**ARINC SPECIFICATION 858 PART 3
TABLE OF CONTENTS**

The Common IPS Radio Interface (CIRI) protocol specified in this standard is intended to facilitate this harmonization by providing a standardized means to exchange status and information in a manner that allows different radios to assess/present link status and to handle the flow of information consistent with the radio's abilities. Therefore, the CIRI protocol should be adopted, by reference to this standard, as the radio standards are updated.

Figure 2-1 – Common IPS Radio Interface

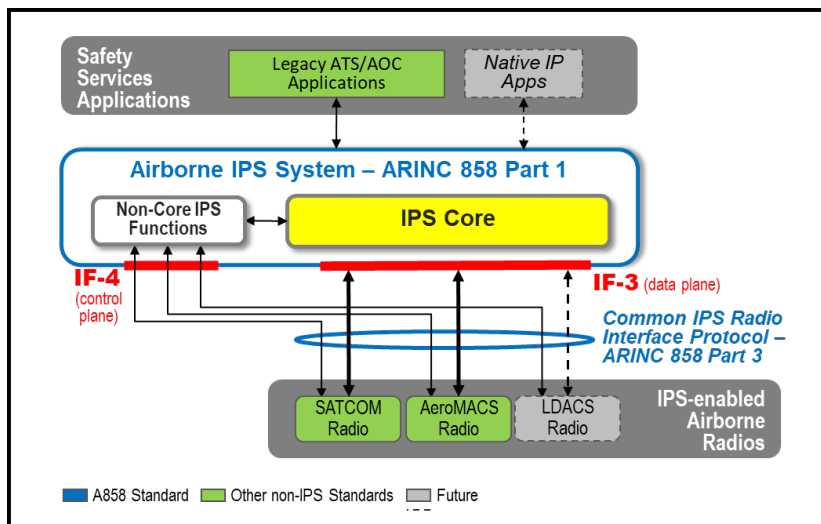
Commented [SM2]: M23 – Definition of IF-4 in Part 1 needs to be fixed – it is not expected that Airborne IPS System would control the radios (tune frequencies, etc.)

Figure 2-2 – Notional CIRI Protocol Context

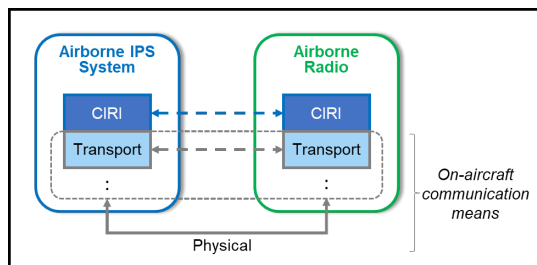
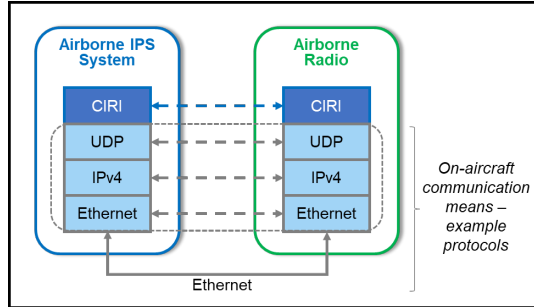
Commented [SM10]: [P3-M22-01 – M.Skorepa/Z.Jaron-HON]: Clarify the diagram to indicate that it is an example, or abstract the diagram.

Commented [OML11R10]: M23 – Fig 2-2 is abstracted; Fig 2-3 is example.

Figure 4-5 – Example Operation of the Airborne IPS System CIRI Endpoint Data Plane in the Air-Ground Direction with Flow Control

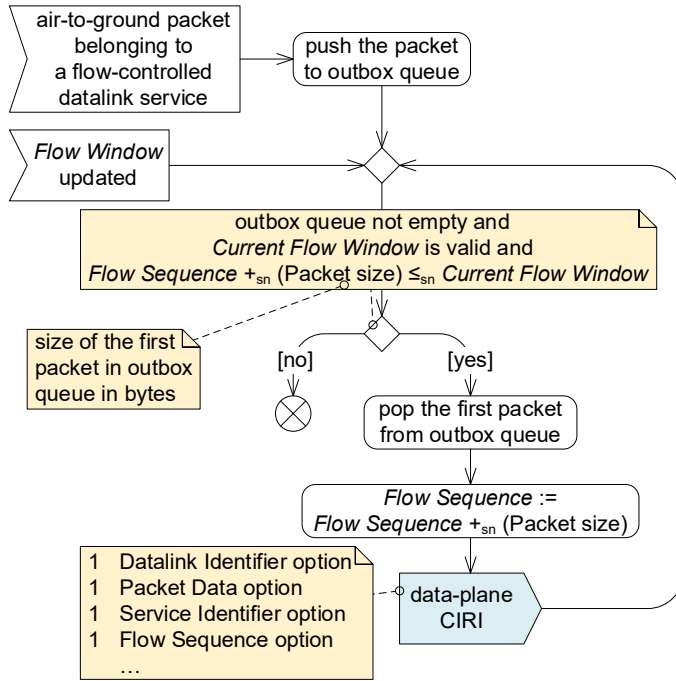
Commented [FW81]: In this figure: Recommendation: Move the text "[outbox queue not empty and current flow ...]" above the diamond box and label the outgoing arrows with "Yes"/"No". IMHO, this will increase readability a lot.
